**To:** Lake Jackson Ecopassage Project Advisory Group  
**From:** Clay Carithers, Leon County Dept. of Community Development  
**Subject:** **Leon County Environmental Permitting Concerns & Related Issues**  
**Date:** February 11, 2003

## LAKE JACKSON ECOPASSAGE PROJECT PRELIMINARY COUNTY PERMITTING CONCERNS AND ISSUES

FIGURE 1

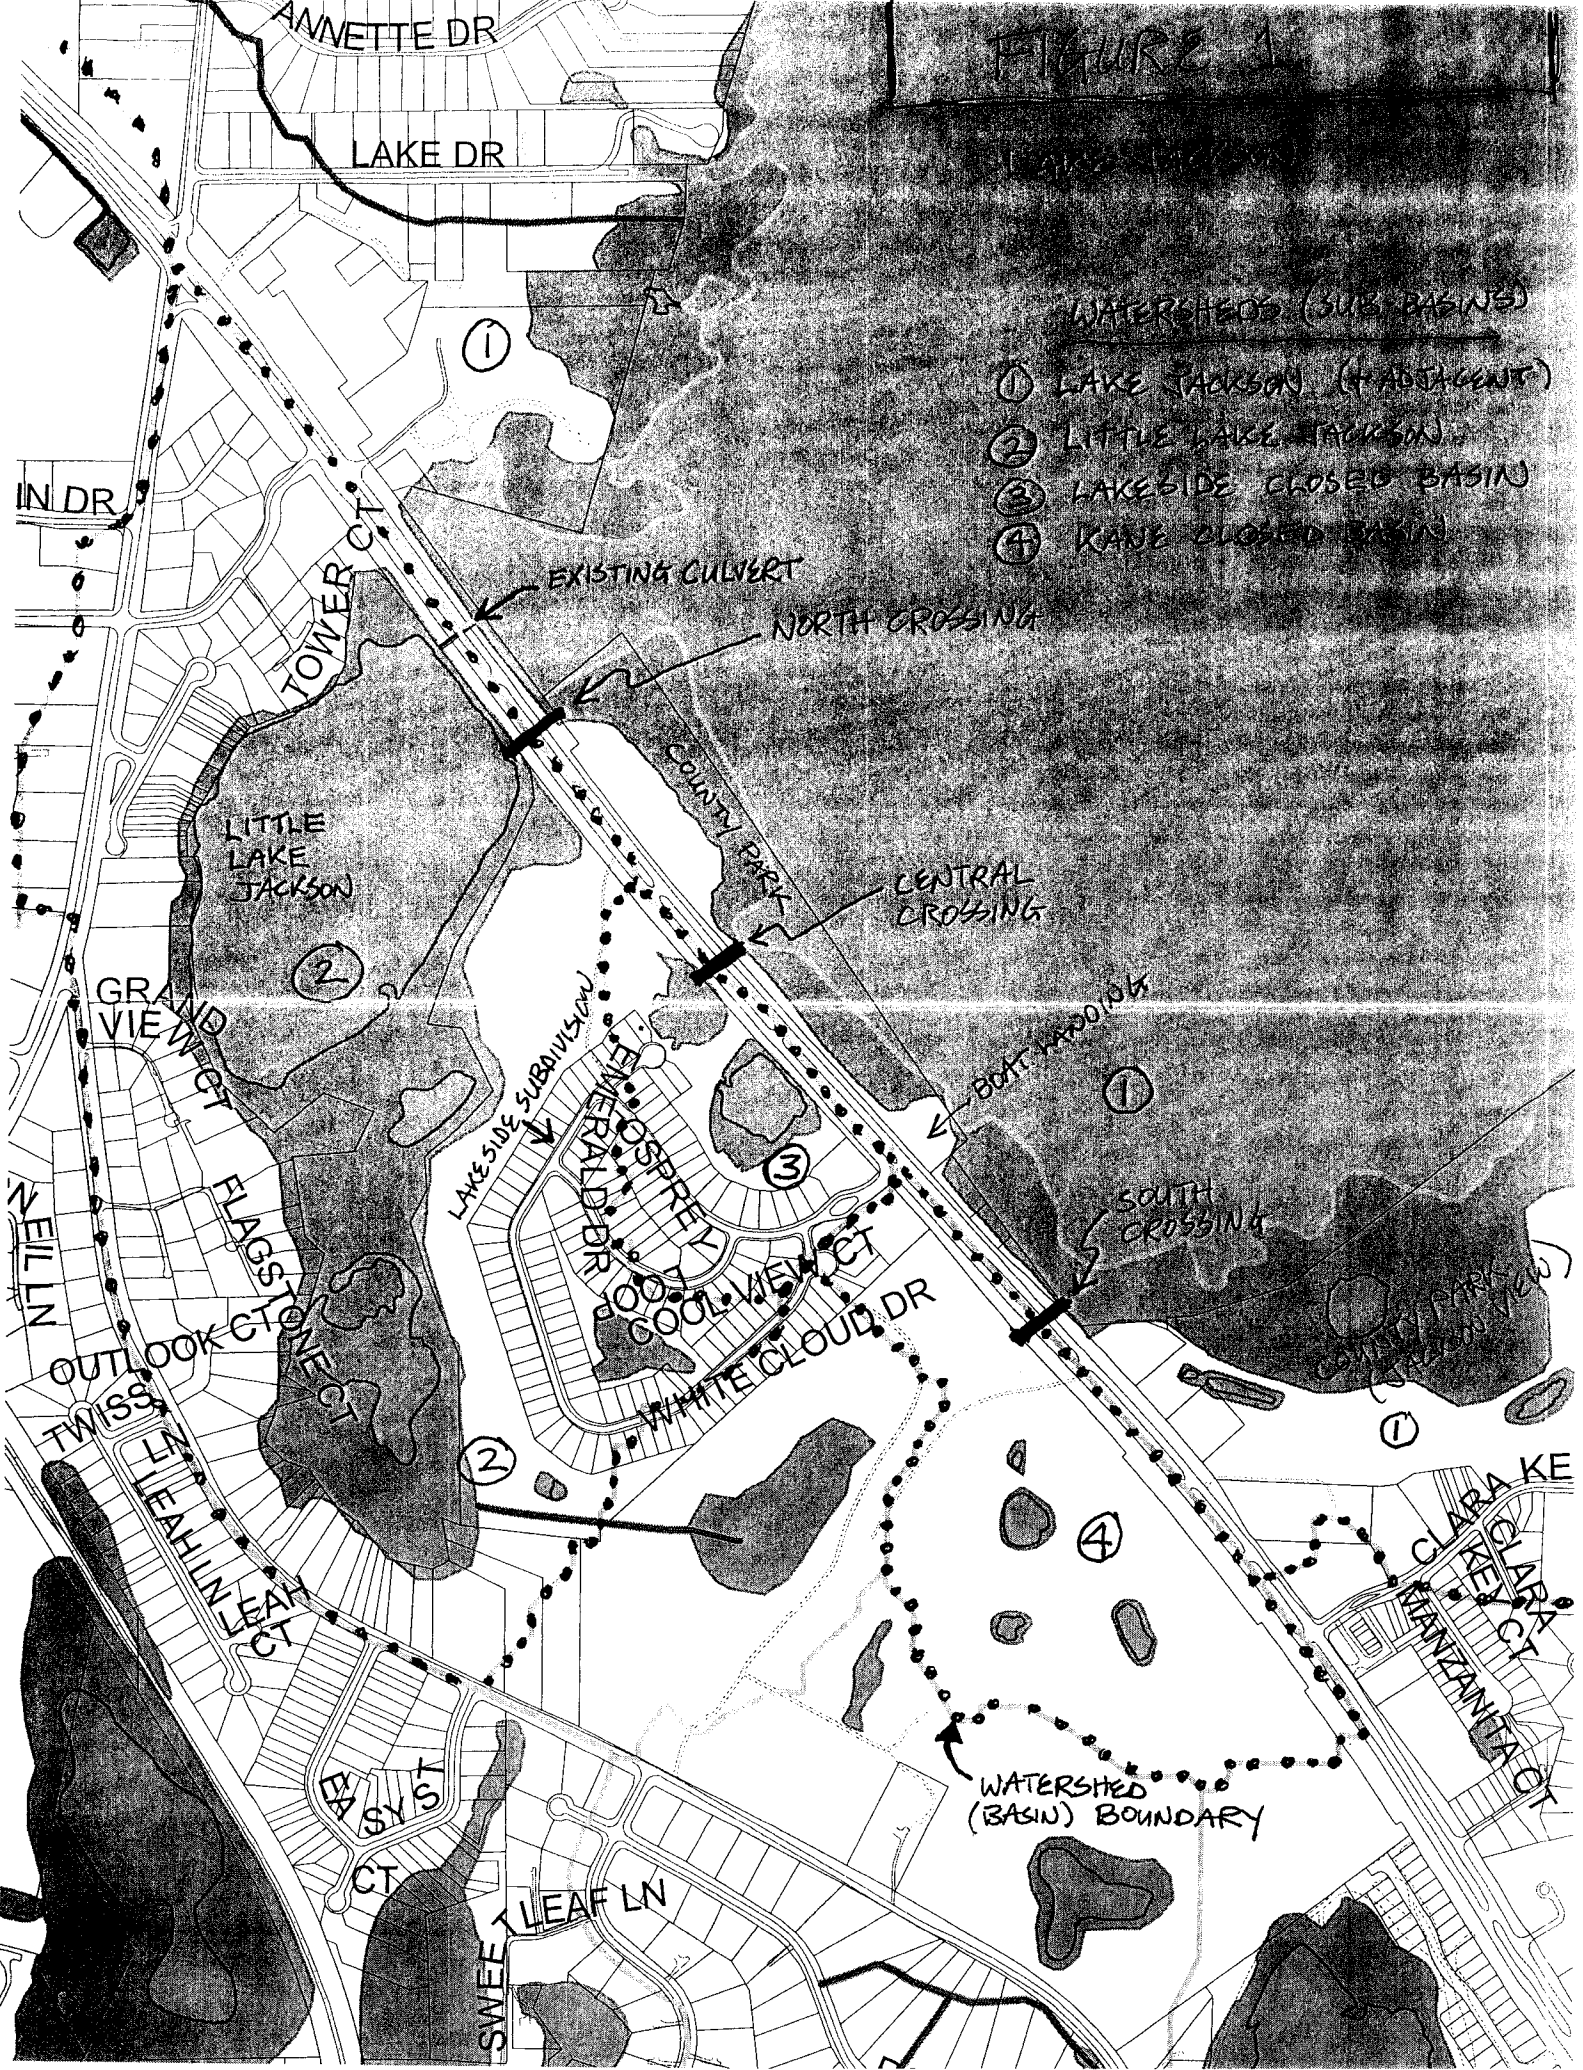
The northern crossing would entail a hydraulic connection between the Lake Jackson watershed and the Little Lake Jackson watershed (see Figure 1). Since there is an existing culvert under US27 connecting these two watersheds, the proposed crossing culvert would not establish a new hydraulic connection where none exists today. Given this, we do not foresee any significant permitting challenges as regards the northern crossing, nor did we express any concerns about this crossing in the advisory group meeting of 11/21/02.

The central crossing would create a new hydraulic connection between the Lake Jackson watershed and the Lakeside Closed Basin watershed (see Figure 1).

The central crossing would create a new hydraulic connection between the Lake Jackson watershed and the Kane Closed Basin watershed (see Figure 1) situated on property owned by Mary Sellers. The property is essentially undeveloped at this time but may be developed in the future.
